East Anglia ONE North and East Anglia TWO Offshore Windfarms

Applicants' Comments on SASES' Deadline 1 Submissions

Applicant: East Anglia TWO and East Anglia ONE North Limited
Document Reference: ExA.AS-20.D3.V1
SPR Reference: EA1N_EA2-DWF-ENV-REP-IBR-001151

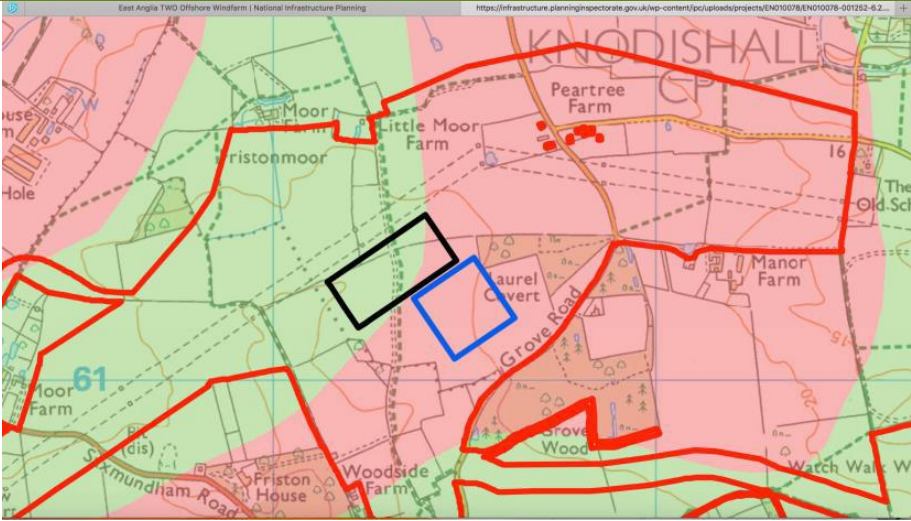
05	<p>5. This is due to the very high amount of the best and most versatile agricultural land (grade 2 and 3) being lost at the substation complex site. This loss has been exacerbated by:</p> <ul style="list-style-type: none"> - choosing a sensitive landscape and heritage location where, in an attempt to mitigate the landscape and heritage impacts, a very large and disproportionate amount of the best and most versatile (BMV) land is made over to tree planting/landscaping; - choosing a site with a high surface water flood risk which requires BMV land to be made over to SuDs ponds; - choosing a site which necessitates the construction of a very long and wide operational access road (1700m x 8m) over BMV land. 	<p>With regard to best and most versatile (BMV) land and compliance with EN-1 paragraph 5.10.8, the Applicants refer to their response to ExA Q1.9.9 in Applicants’ Responses to Examining Authority’s Written Questions Volume 11 - 1.9 Land Use (REP1-114). BMV land is considered in line with the NPS and is reflected by an assignment of high magnitude in Table 21.8 of Chapter 21 Land Use (APP-069) (Table 21.8). This is factored into impact significance.</p> <p>62.9% of the land within the footprint of the onshore development area is of BMV classification (i.e. Agricultural Land Classification (ALC) Grade 2 and 3)). During the site selection process the Applicants assigned weighting to Agricultural Land Classifications as described in Appendix B of Appendix 4.2 RAG Assessment for Onshore Substations Site Selection in the Sizewell Area (APP-443). Grade 1 was assigned red, Grade 2 and 3 amber and Grade 4 green which</p>

ID	Written Representation	Applicants' Comments
		<p>reflect the BMV ALC classifications. This formed part of the Applicants' quantitative site selection assessment alongside other site constraints.</p> <p>The amount of BMV land within the entire onshore development area as a percentage of total BMV land in Suffolk is 0.14%. This is negligible in the context of Suffolk's regional farming resource. There is no agricultural land of the highest quality (Grade 1) within the proposed onshore development area. It is the view of the Applicants therefore that the NPS has been complied with.</p> <p>The Applicants also refer to the Project Update Note (REP2-007) submitted at Deadline 2 regarding the onshore substation footprint reduction. Since submission of the Applications, the Applicants have undertaken extensive engagement with the supply chain regarding the design of the onshore substations and as a result the Applicants can confirm a reduction in the maximum footprint of each onshore substation to 190m x 170m. This represents an approximate 10% reduction in the development footprint of each onshore substation.</p>

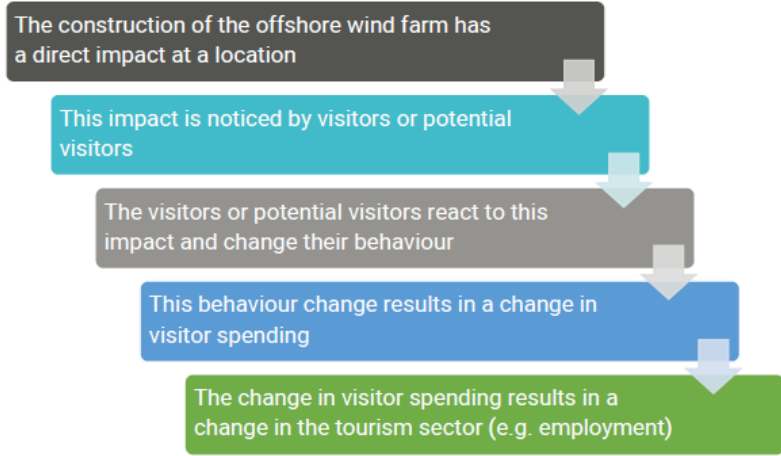
ID	Written Representation	Applicants' Comments
02	<p>Mitigation Measures</p> <p>13. The following mitigation measures be put in place.</p> <ul style="list-style-type: none"> • There must be a reduction in working hours so that residents are not impacted by 24 hour a day works needing lighting, and, especially during the winter months, the planned 12 hour a day works are shortened. The National Planning Policy Framework 2019, unfortunately makes little reference to lighting with regard to the control of obtrusive light, but it does state: “c) limit the impact of light pollution from artificial light on local amenity, intrinsically dark landscapes and nature conservation”. • The Applicant’s proposed ‘Operational Artificial Light Emissions Plan’ and any other substation developers must conform to published standards and guidance for lighting eg Commission Internationale De L’Eclairage (CIE) document which would support mitigation of aspects of intrusive lighting. • Any developer working on the proposed development and any other/later projects at the site must conform to all British Standards in relation to the lighting of roads, places of work and the methods of measuring lighting performance. • The Local Authority must work with the Applicant and any other developer throughout the construction and working stages, in accordance with the Clean Neighbourhoods and Environment Act 2005 (CNEA), to ensure that no light emitted from the proposed works constitutes as a statutory nuisance. • The Local Authority must specify, to any developer working on the project, the ‘environmental zone’ which incorporates the proposed development, ie. E1 would constitute a Natural zone with a dark lighting environment (eg relatively uninhabited rural areas, National parks, Areas of Outstanding Natural Beauty, IDA buffer zones), E2 would constitute a Rural zone with low district brightness (sparsely inhabited rural areas, village or relatively dark outer suburban 	<p>The Applicants note SASES recommendations for controlling and mitigating lighting impacts.</p> <ul style="list-style-type: none"> • Construction activities would normally be conducted during Monday to Friday working hours of 7am to 7pm and Saturday working hours of 7am to 1pm. Working hours are not proposed for Sundays or Bank Holidays. These working hours have been reduced on Saturdays from those originally proposed following feedback received from Section 42 consultation. Residents will therefore not be affected by 24hr a day works needing lighting. This is secured under requirements 23 and 24 of the draft DCO (an updated version has been submitted at Deadline 3, document reference 3.1); • The Operational Artificial Light Emission Plan will be produced in line with best practice such as British Standards and industry guidance; • With regard to the Clean Neighbourhoods and Environment Act 2005, site lighting will be positioned and directed to minimise nuisance to footpath users and residents, to minimise distractions to passing drivers on adjoining public highways and to minimise sky glow, so far as reasonably practicable. Details of the location, height, design and luminance of all floodlighting to be used during the construction of the Projects, together with measures to limit obtrusive glare to nearby residential properties, will be set out in the Artificial Light Emissions Management Plan (required under Requirement 22 of the draft DCO (an updated version has been submitted at Deadline 3, document reference 3.1));

ID	Written Representation	Applicants' Comments
	<p>locations). The environmental zone identified would enable the recommended 'Maximum values of vertical illuminance on properties' both Pre and Post-curfew, the 'Limits for the luminous intensity of bright luminaires Pre and Post Curfew, the 'Maximum values of upward light ratio (ULR) of luminaires', the 'Maximum permitted values of average surface luminance (cd/m2)' and the 'Maximum values of threshold increment and viewing direction in paths of travel' to be identified.</p> <ul style="list-style-type: none"> • Obtrusive Light (whether visible from residents' homes or impeding the view of the night sky) and Sky Glow must be substantially mitigated, there must be a guarantee of no light spill and no light intrusion causing a 'nuisance' to others and adversely affecting fauna and flora. • Light sources (lamps/LEDs) must be those which combat the problem of obtrusive light. "Most night-time visual tasks are only dependent on light radiated within the visual spectrum. It is therefore not necessary for light sources to emit either ultra-violet or infra-red radiation (unless specifically required to do so). Research indicates that light from the blue end of the spectrum could have important adverse effects on fauna and flora". xi The blue light spectral power of the light source should be considered by SPRs designers with the needs of the task balanced with its impact on the environment including fauna and flora. Low temperature LEDs and compact fluorescents should be used. Outdoor fixtures should use longer-wave LEDs rather than bright-white lights which would limit the impact on light sensitive animals. • The Applicant, and any other developer on the proposed project, must thoroughly assess the use of the area by bats (before artificially lighting in the vicinity of a bat roost or where bats may commute or forage). They must ensure that Natural England are fully aware of the full assessment any impacts and appropriate mitigation has been considered within any mitigation licence 	<ul style="list-style-type: none"> • With regard to environmental zones and the AONB, during construction of the onshore cable route, short-term, temporary effects from lighting on the relative tranquillity of the area of the AONB between Thorpeness, Sizewell and Leiston will primarily be experienced. These effects would occur over several separate short 2-3 month periods of peak construction activity and not continuously throughout the construction phase. Edges of the AONB near Leiston have more urban development influences and are less impacted by changes resulting from the onshore cable route construction; • The Applicants propose to use directional beams, non-reflective surfaces and barriers and screens, to avoid obtrusive light whilst maintaining safety and security obligations; • With regard to impacts on fauna and flora, all temporary lighting will be designed in line with the BCT Guidance Note 8 Bats and artificial lighting (2018). This is to include the use of directional lighting during construction. It will also be ensured that dark corridors remain in place during the construction phase; • As discussed in row 26 of Table 2.9 Ecology, the Applicants will undertake pre-construction surveys as detailed in the OLEMS (an updated version has been submitted at Deadline 3, document reference 8.7) in order to determine how many bat roosts will be affected to inform the mitigation strategy; and • With regard to installation height, details of the location, height, design and luminance of all floodlighting to be used during the construction of the Project, together with measures to limit obtrusive glare to nearby residential properties, will be set out in the Artificial Light Emissions Management Plan (required under
